From: Scala, Mary Joy
Sent: Monday, March 21, 2016 11:53 AM
To: 'Robert Nichols'
Cc: andrew@corecville.com
Subject: BAR Action - March 15, 2016 - 550 E Water Street

Certificate of Appropriateness Application

BAR 15-10-08
550 East Water Street
Tax Parcel 530162300
Neal Sansovich, Owner/ Andrew Baldwin, Applicant
New Mixed-Use Complex

**CITY OF CHARLOTTESVILLE
BOARD OF ARCHITECTURAL REVIEW
STAFF REPORT
March 15, 2016**

WEST ELEVATION

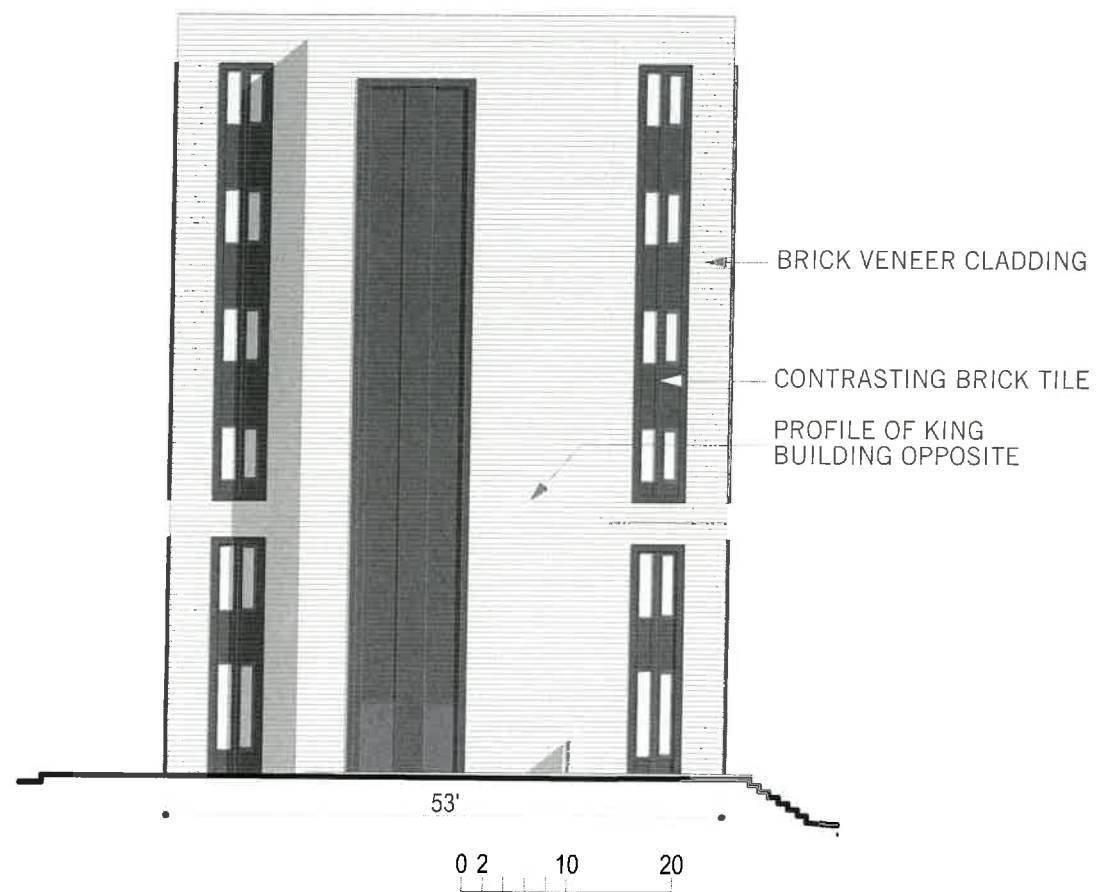
- **Planting and lighting plan**
- **Revised mortar detail**
- **How the applicant intends to deal with site walls and fencing**
- **Continuing design development on warming up façade on street side and west elevation.**
